# UNITED STATES PATENT AND TRADEMARK OFFICE

APPLICATION NO.	FILING DATE	FIRST NAMED INVENTOR	ATTORNEY DOCKET NO.	CONFIRMATION NO.
09/910,414	07/20/2001	Eric P Berg	NIGA,003	9647
<div>7590 Mark R Wisner WISNER &amp; ASSOCIATES Suite 400 1177 West Loop South Houston, TX 77027-9012</div>			<div>EXAMINER BANGACHON, WILLIAM L</div>	
			<div>ART UNIT 2612</div>	<div>PAPER NUMBER</div>
SHORTENED STATUTORY PERIOD OF RESPONSE	MAIL DATE	DELIVERY MODE		
3 MONTHS	01/16/2007	PAPER

## Office Action Summary

## DETAILED ACTION

**Figure 1**

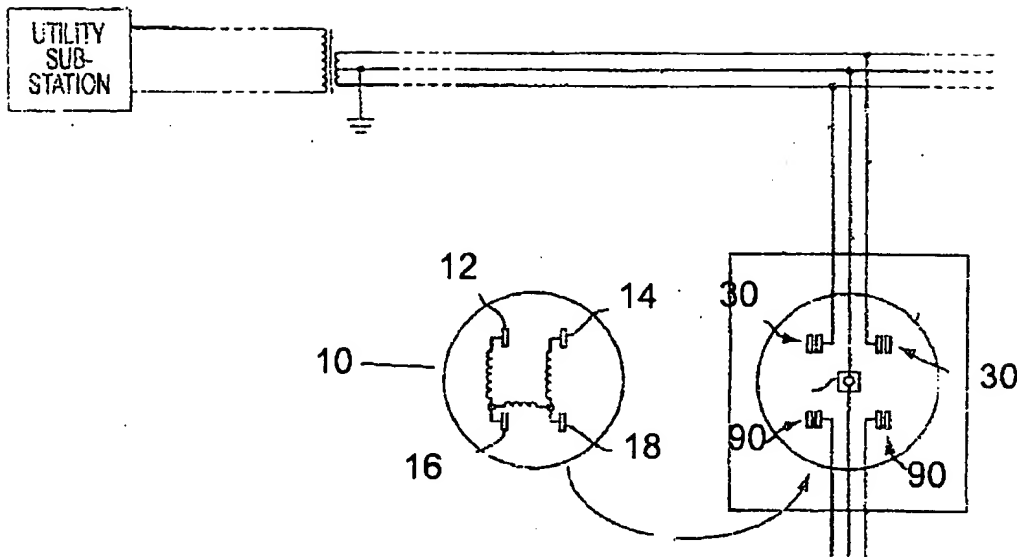
2. The drawings were received on 11/24/2006. These drawings are acceptable.
